**HISTORIC PRESERVATION BOARD
CITY OF PORTLAND, MAINE**

**WORKSHOP
1 COMMERCIAL STREET**

RE: October 19, 2016 **Workshop (2nd) – Preliminary Review of
Comprehensive Exterior Renovation**

**WORKSHOP
39 DEERING STREET**

ATT. 2a
REVISED
PROPOSAL

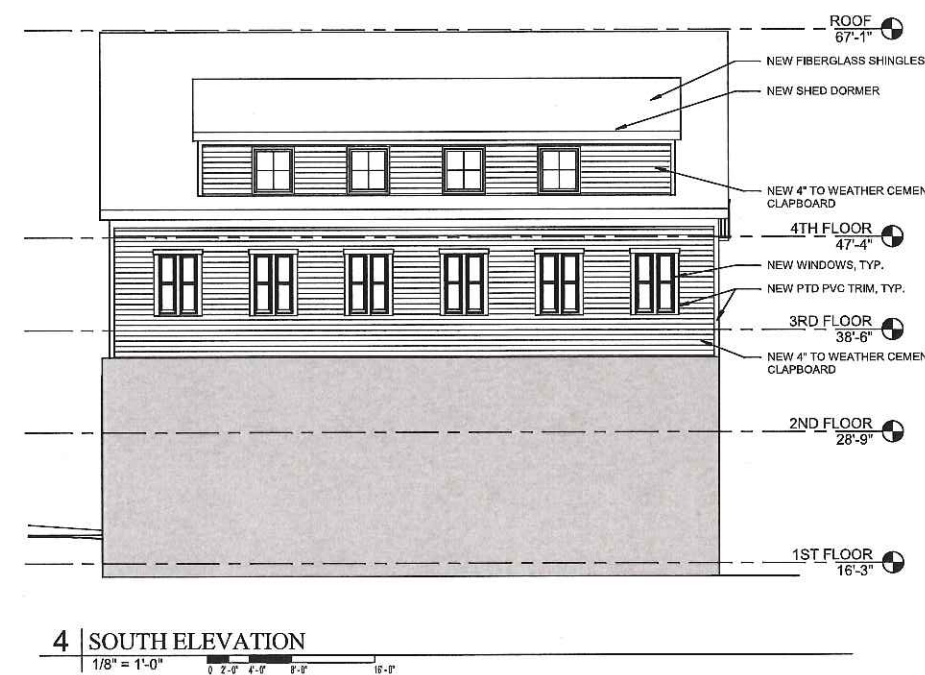
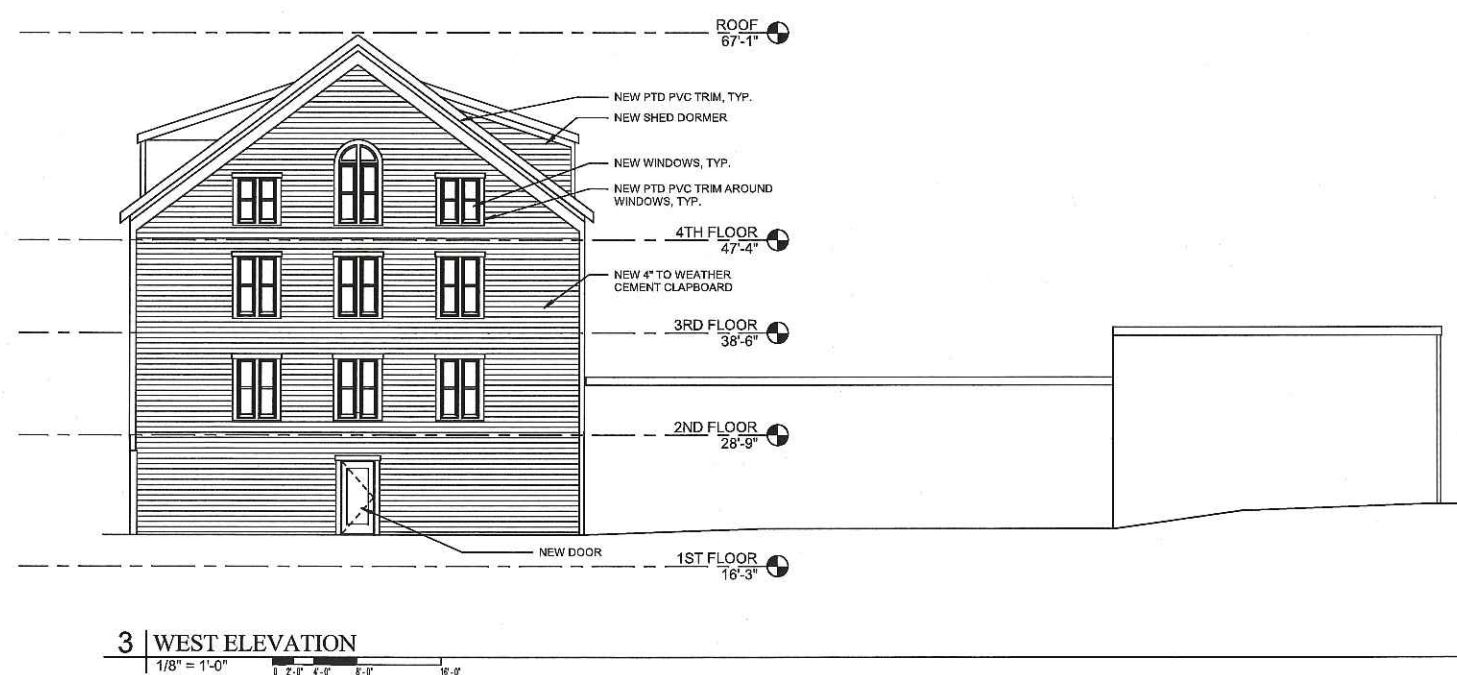
In staff's view, previous concerns about the window-to-wall ratio on the upper façades have been satisfactorily addressed with the resizing of the windows. It appears that the window trim has been narrowed a bit as well, which is also an improvement. As well, the changes to the west-facing dormer are very positive. Regarding the east-facing dormer, the shed roof addition seems unresolved; perhaps a more refined cornice detail, an alternative post solution or other adjustments would resolve these concerns. Staff does not support the proposed introduction of a wide balcony and three French doors on the Commercial Street elevation. Although the

building originally featured a balcony, the new balcony is in no way reminiscent of the original and represents a visually distracting, clearly contemporary intervention on the historic building's primary façade. Regarding the changes to trim details, staff notes that the cornice treatment is still much simpler than the original building cornice. In staff's view, careful attention to these architectural details will make a significant impact on the success of this rehabilitation project.

1. Corner boards now shown.
2. West facing dormer moved up and fenestration modified.
3. Windows re-proportioned, all windows on second floor and third are same dimension.
4. South elevation redesigned going back to original window proportions. Note the building owner wants very much to incorporate a French Style Balcony on the fourth floor. We have designed a simple painted steel railing and floor grate. It projects out 12 inches. We tried to keep it light, to not overpower the elevation. We hope that this can be viewed as acceptable by the board.

ATT. 3-a
ORIGINAL
PROPOSAL

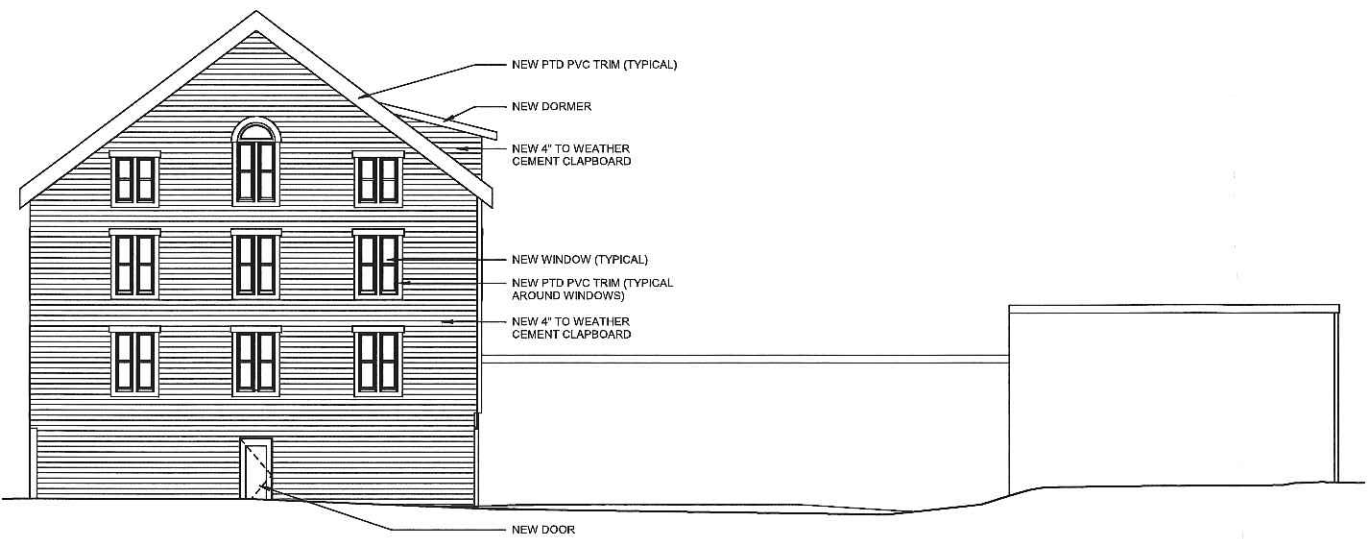
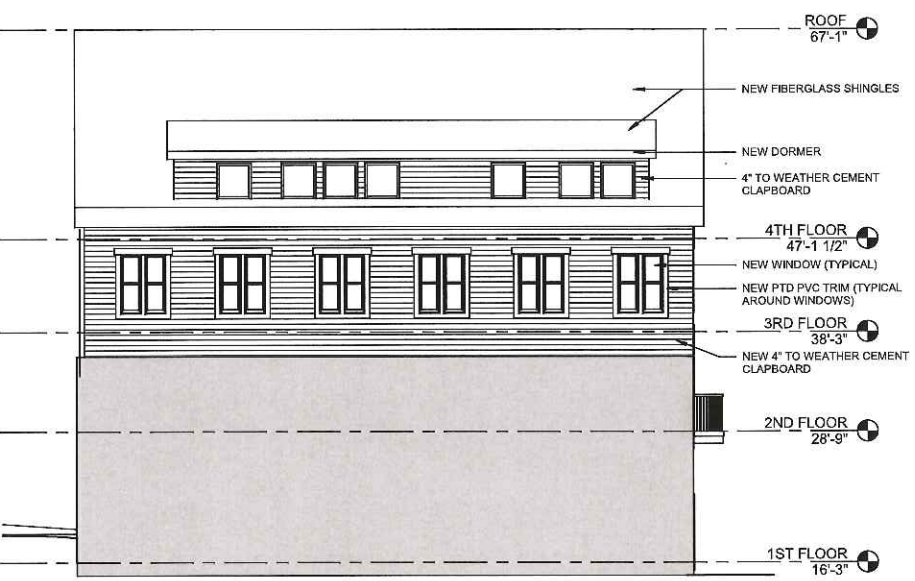
- Some of the **architectural details** evident in the 1924 photographs (e.g. cornerboards) were missing from the proposed design. Other original details, such as the cornice, had been simplified in the architect's proposal. Board members noted that these traditional details were important in conveying the building's age and architectural period. Simplifying or eliminating these architectural details would likely result in a building that would read as a new structure inspired by traditional design, rather than a rehabilitated historic structure.
The latest elevations include cornerboards and a modified cornice design (although the new cornice treatment still appears to be simpler than the original.) Staff cannot comment on the ground floor treatment, as details have not yet been provided.

- Regarding the **west-facing dormer**, Board members questioned its position on the roof plane as well as its proposed fenestration. Mr. Lloyd was encouraged to move the face of the dormer back from the building's wall plane and to establish a more orderly window pattern.
In the revised proposal, the dormer has been pushed back from the wall plane and the dormer windows are regularly spaced and aligned with the upper floor windows.

- Board members expressed concern that the inverted **east-facing dormer** represented a significant departure from the design vocabulary of the building and was visually distracting. They noted that unlike the inverted dormers approved for rear roof planes, this dormer would be particularly prominent on a building of this scale in this corner location. Mr. Lloyd was encouraged to explore adding a shed roof over the inverted dormer to better integrate it with the principal roof.
The revised proposal includes a shed roof supported by corner columns or posts.

- Board members noted that the **window-to-wall ratio on the India Street elevation** did not appear consistent with the building's historic appearance. They encouraged that the sizes of the windows be reexamined and adjusted.
The windows on the India Street elevation have been re-sized.

- Board members noted that the mullion detail of the proposed **arched-top windows** at the center of the Commercial Street façade did not match those of the original windows. Mr. Lloyd was asked to adjust the window detail accordingly.
Although the mullion detail has been revised, the latest Commercial Street elevation shows the paired arched-top windows at the second floor level only. At the third floor level, these windows have been eliminated. At the fourth floor level, the center arched top window has been replaced with French doors. The flanking double hung windows have also been replaced with French doors. The doors lead to an extended-width balcony.

- Board members did not support the contemporary treatment of the balcony shown at the second floor level. If a balcony is reintroduced, Board members argued that it should replicate the original design or be eliminated altogether. In response to a question from Mr. Lloyd about the possibility of adding a balcony at the fourth floor level, Board members indicated that they did not support a balcony at that location and noted that the inverted dormer at the fourth floor level provided outdoor space for the residential unit.

1 SITE PLAN
SCALE: 1/8" = 1'-0"

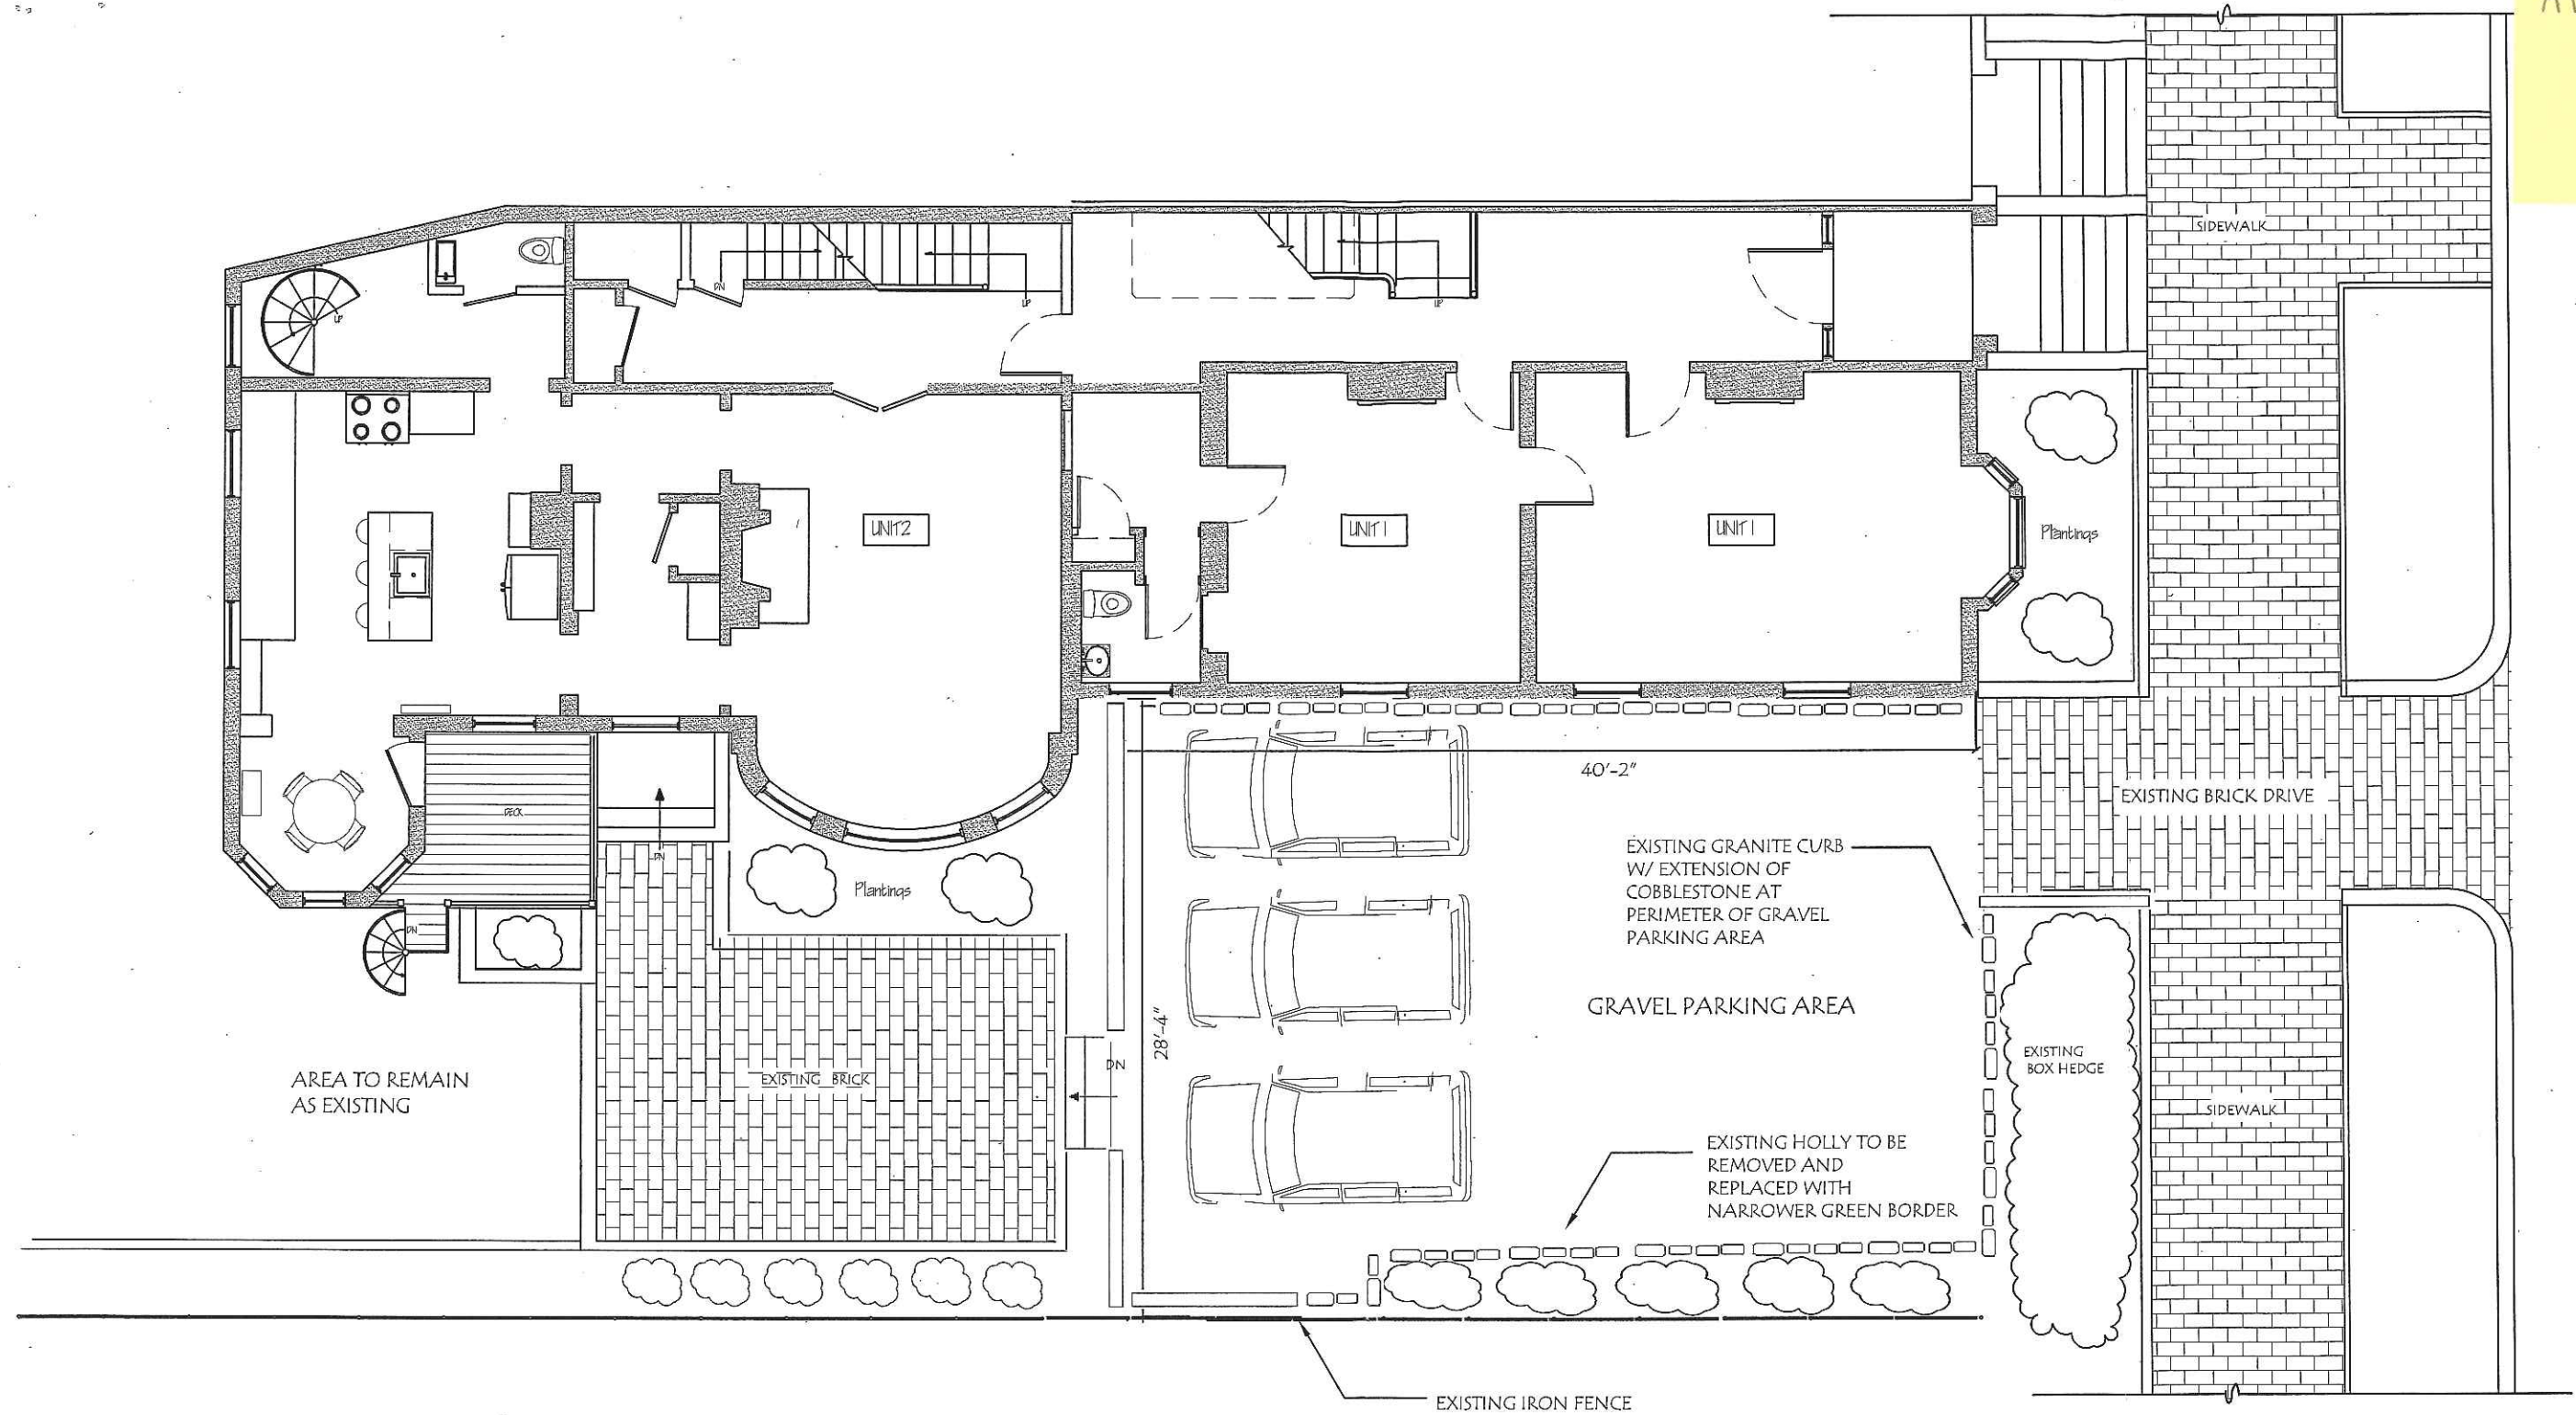
Staff has no doubt the proposed alterations would be similarly well crafted. While the green buffer at the sidewalk and the left side may be somewhat diminished if the proposed changes are made, there will still be plantings along both boundaries. Nonetheless, cars would be visible, and staff suggests the Board must evaluate whether the expanded parking would undermine the distinguishing original qualities and character of the site.
